Project Addendum 1
(1 page, 5 attachments)

Project: FY21 Zadio E. Kuehl Dog Park

Date: August 5, 2020

**STANDARD PEDESTRIAN
PATHWAY SECTIONS**

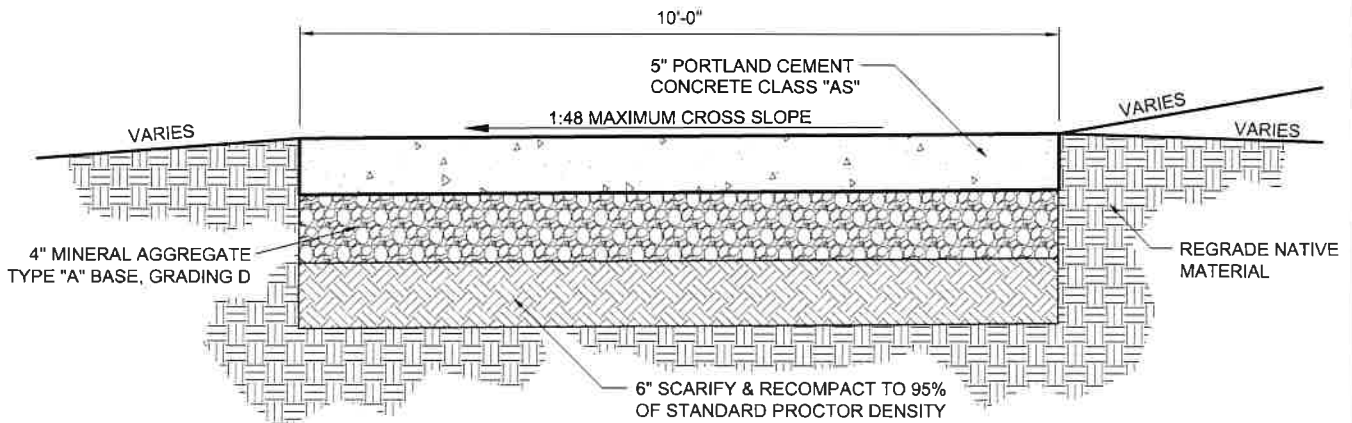
5. Add Standard Pedestrian Pathway Section Detail to Appendix A
6. Add Fence and Gate Specifications to Appendix A
7. Add Water Fountain Specifications to Appendix A
